Earraghail Renewable Energy Development

Additional Information

February 2023

RESPONSE TO THE REPRESENTATION ON BEHALF OF THE WOODLAND TRUST, IN RELATION TO THE APPLICATION FOR CONSENT FOR THE PROPOSED EARRAGHAIL RENEWABLE ENERGY DEVELOPMENT (RED) BY SCOTTISHPOWER RENEWABLES (SPR)

Panoramic photo looking W-N-E from NR 84260 65672

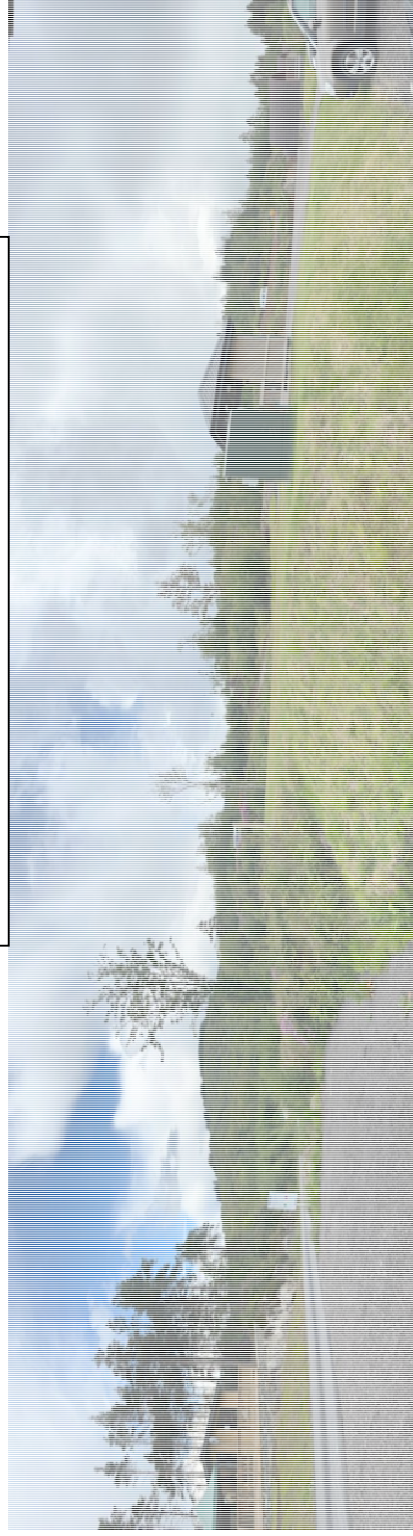
The Woodland Trust's response under the title "Mitigation" states the following. *"The proposed construction compound should be re-located outside of the ancient woodland area and afforded a buffer zone of at least 15 metres. HERAS fencing fitted with acoustic and dust screening measures should also be put in place during construction to ensure that the buffer zone does not suffer from encroachment of construction vehicles/stockpiles, and to limit the effects of other indirect impacts.*

The Woodland Trust is correct in stating that the proposed construction compound is located in an area identified in NatureScot's ancient woodland inventory (AWI). Satellite imagery and Ordnance Survey mapping also suggests woodland cover in the area.

However, at design stage surveys undertaken on behalf of SPR by design engineers and ecologists had established that the area included in the AWI where the project team chose to locate the proposed compound did not contain any woodland. The area is located within the Tarbert Holiday Park¹, an operational caravan and glamping site.

Following receipt of the Woodland Trust's representation, SPR appointed ecologists to confirm the observations made at design stage. Please see below two photos taken from NR 84260 65672 which show the current condition of the area identified as AWI in which the proposed compound is located. The ecologists observe that there is no evidence of ancient woodland at the locality, with small areas of relatively young broadleaf and scrub and older pine copses present between areas of road or gravel for the holiday park.

Our assumption is that any ancient woodland that was at that locality was cleared for the holiday park and infrastructure, with any remnant woodland/scrub more representative of younger/non-ancient habitat.

As such, the compound area is already located at least 15 m from any remaining ancient woodland areas, and no movement to the location of the compound is considered necessary.

Figure 1 Forestry Loss Areas Resulting in Compensatory Planting

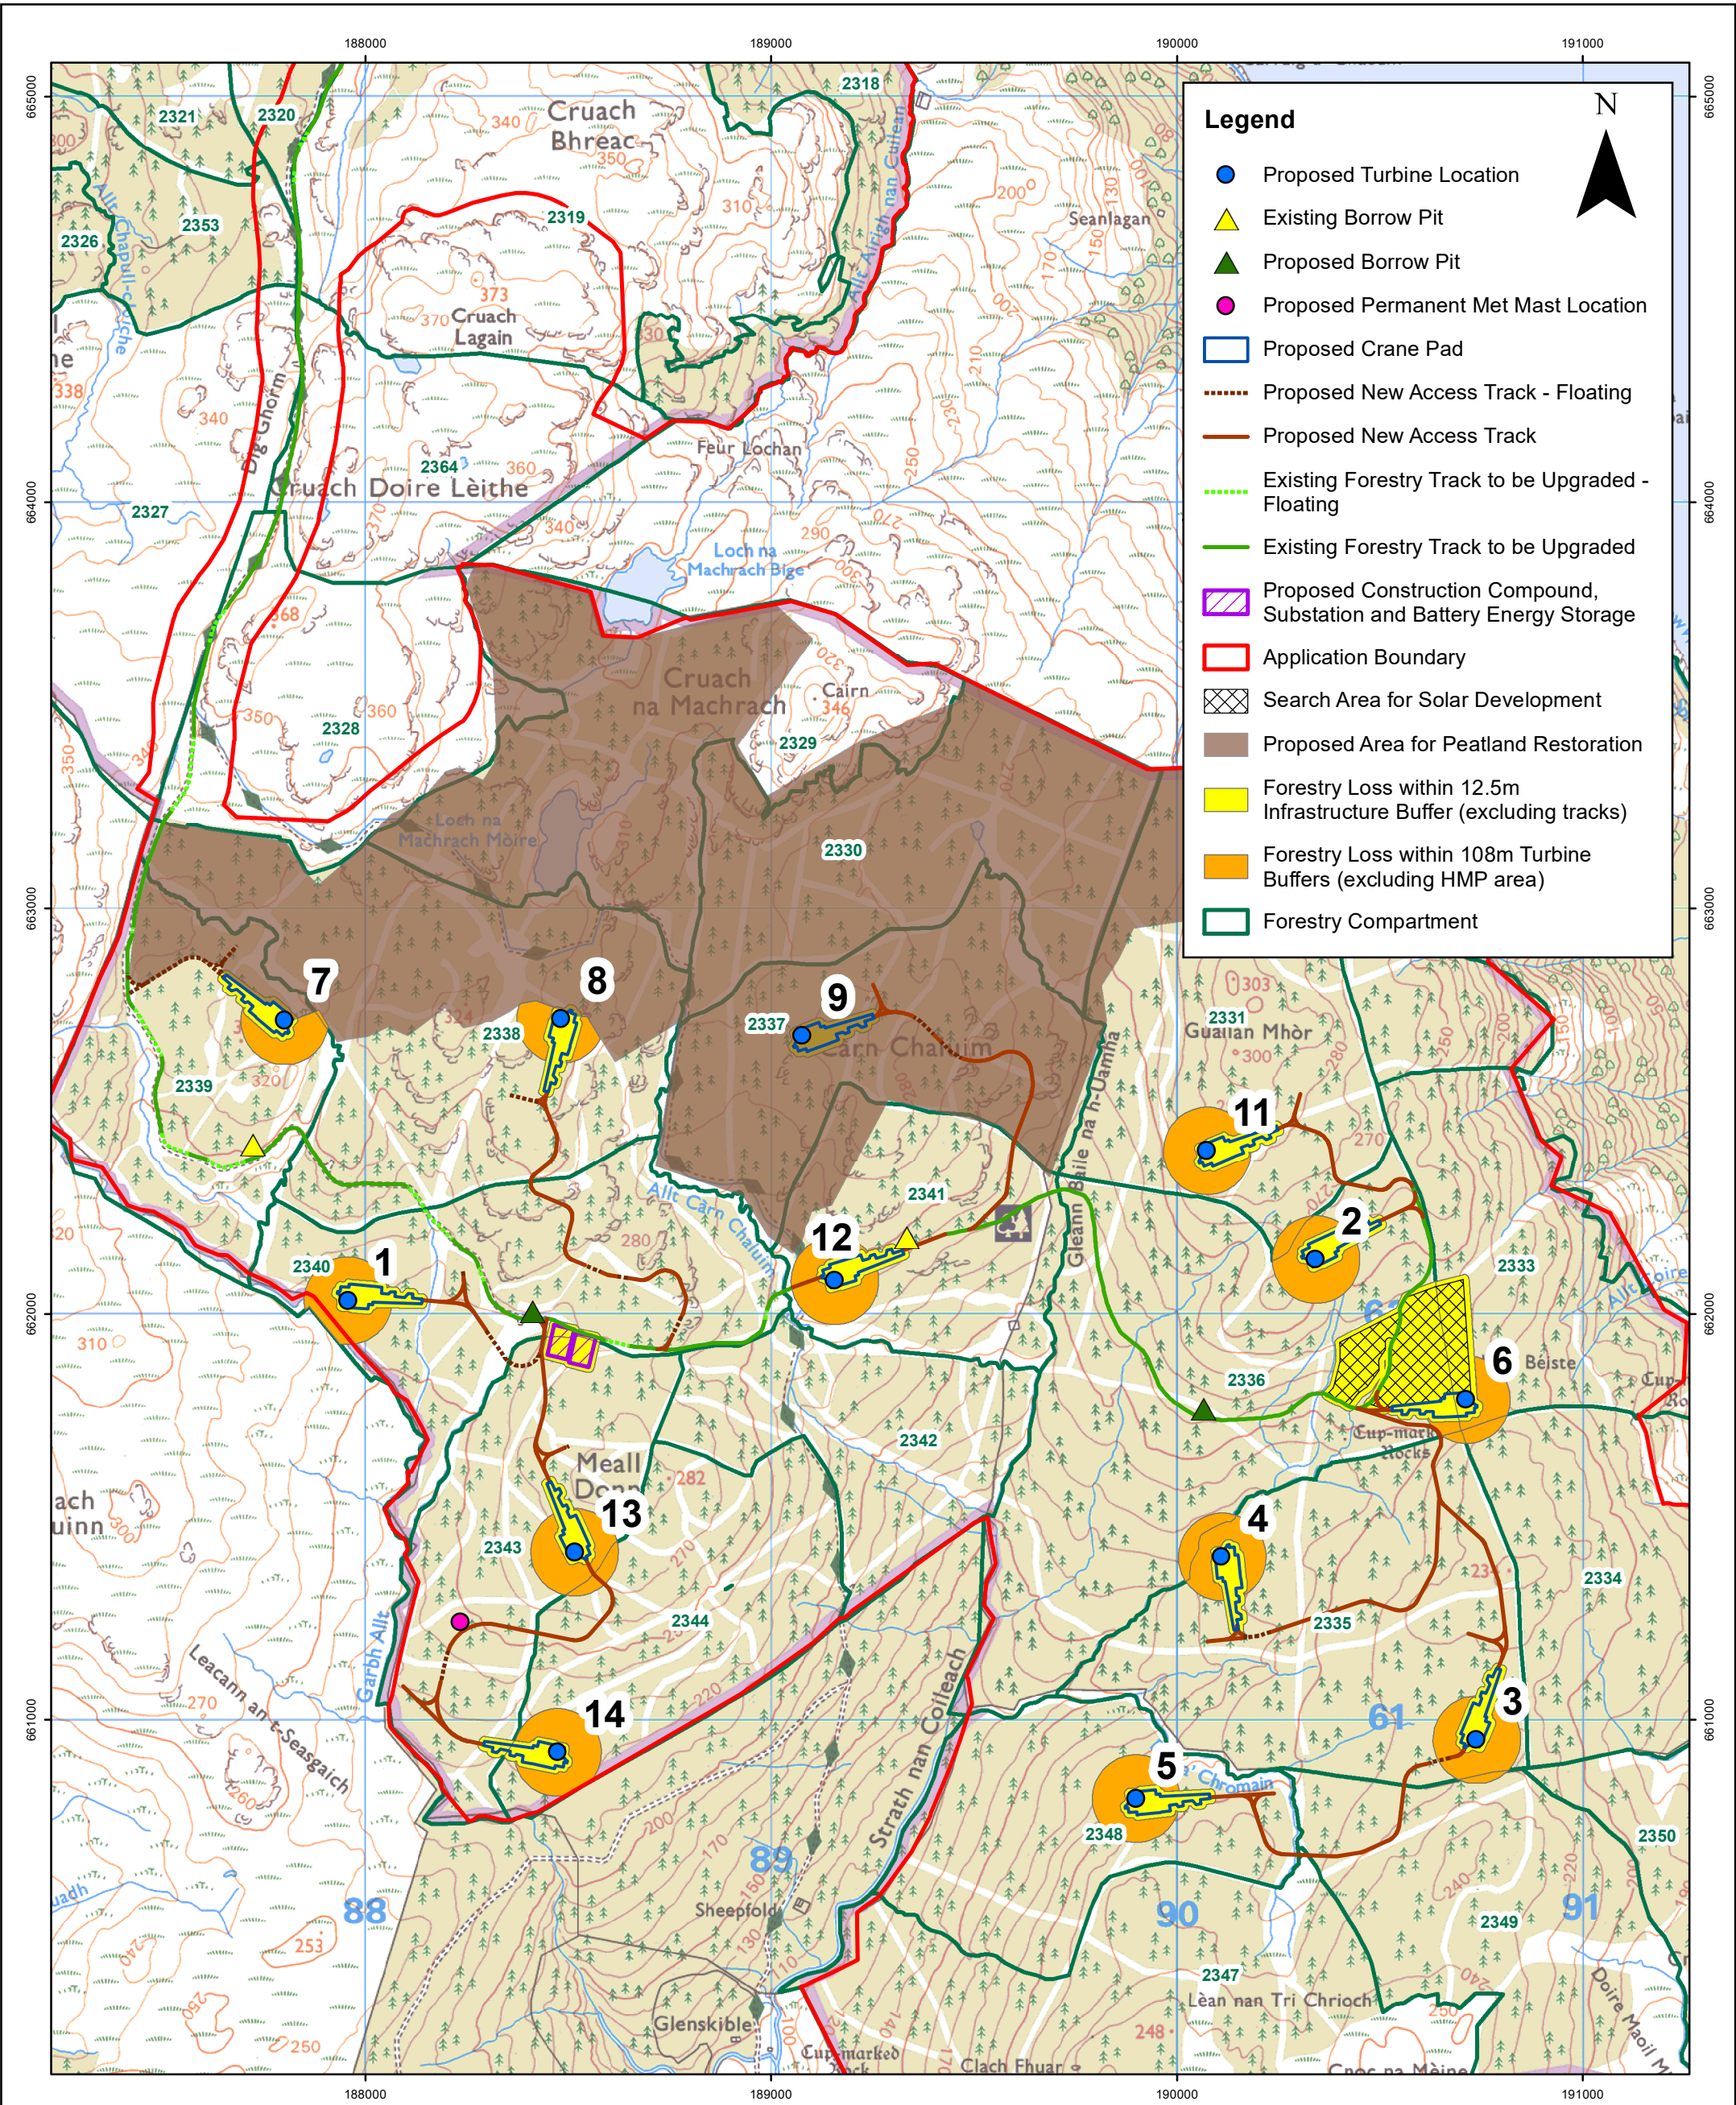
Section 2a) of your letter states, "*We disagree with the Applicants proposal in section '15.8.1 Need for CP' that, subject to a restoration plan, there would be no requirement for CP. [Compensatory Planting]*". Based on our recent correspondence and discussions, we understand that:

Table 15.1.4 of Technical Appendix 15.1 Forestry Assessment of the EIA Report identifies the total area of felling required to accommodate the proposed Development, as 110.79 Ha. During discussion with Scottish Forestry, the above points 1 – 5 were clarified, resulting in a net loss of woodland area for the construction of the proposed Development and a CP requirement of 56.284 Ha. We enclose a plan showing our understanding of the areas requiring CP (yellow and orange polygons), as highlighted to you during our meeting on 5th September 2022, which omit the areas of proposed peatland restoration around Turbine 9 and parts of Turbines 7 and 8.

The Applicant is committed to providing appropriate compensatory planting to comply with the criteria of the Scottish Government's Control of Woodland Removal Policy. As noted in Technical Appendix 15.1 Forestry Assessment, the extent, location and composition of such planting will be agreed with Scottish Forestry, taking into account any revision to the felling and restocking plans prior to the commencement of the operation of Earraghail RED.

I can confirm that the detail provided in RSK's letter of 16.9.22 addresses the concerns raised in our consultation response of 31.3.22.

Scottish Forestry recommend that the 56.3 hectares of compensatory planting described, are secured by a condition similar to that given in Appendix 1 my email consultation response of 31.3.22.
